[Docket No. FAA-2023-0163; Project Identifier AD-2022-01380-T; Amendment 39-22468; AD 2023-12-10]

Airworthiness Directives; The Boeing Company Airplanes

Final rule.

Figure 1 to paragraph (g)(2)(i)— *Fundamental Effective Isotropic PSD at Outside Interface of Aircraft Antenna*

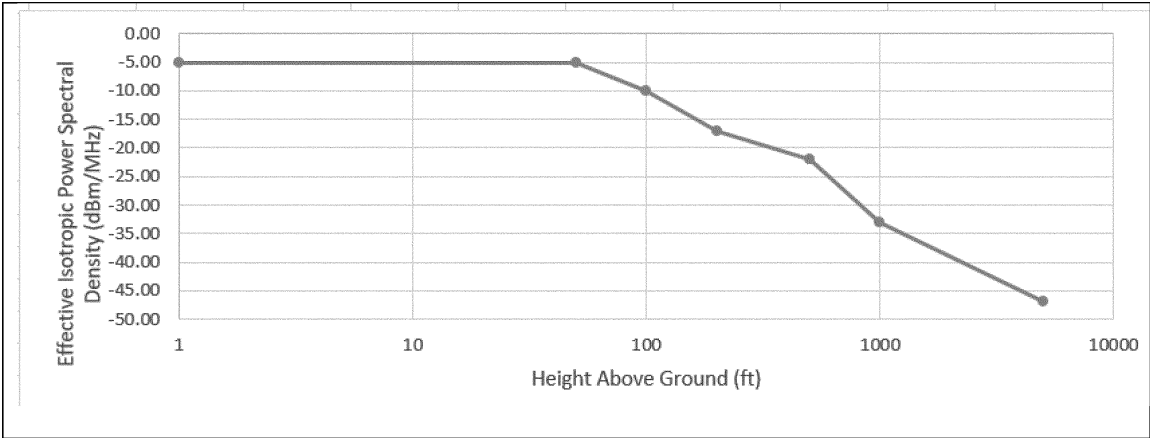
(i) Tolerance to radio altimeter interference, for the fundamental emissions (3.7–3.98 GHz), at or above the power spectral density (PSD) curve threshold specified in figure 1 to paragraph (g)(2)(i) of this AD.

Figure 2 to paragraph (g)(2)(ii)— *Spurious Effective Isotropic PSD at Outside Interface of Aircraft Antenna*

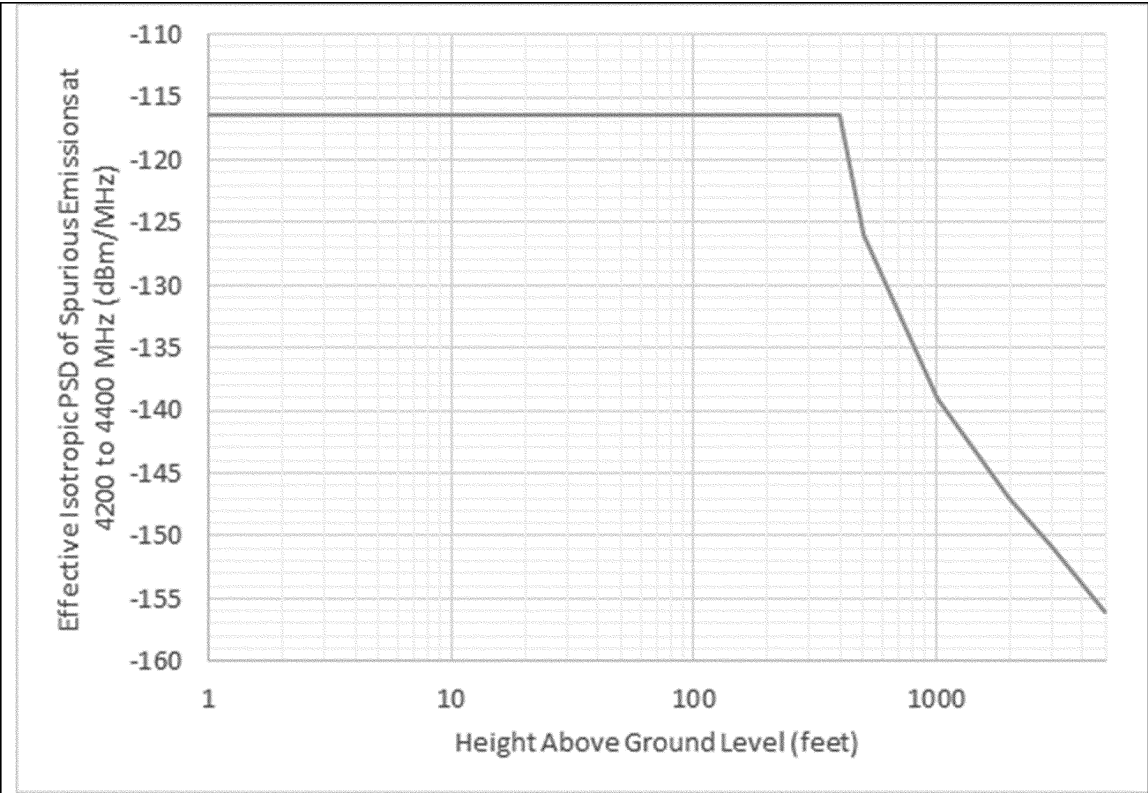
(ii) Tolerance to radio altimeter interference, for the spurious emissions (4.2–4.4 GHz), at or above the PSD curve threshold specified in figure 2 to paragraph (g)(2)(ii) of this AD.
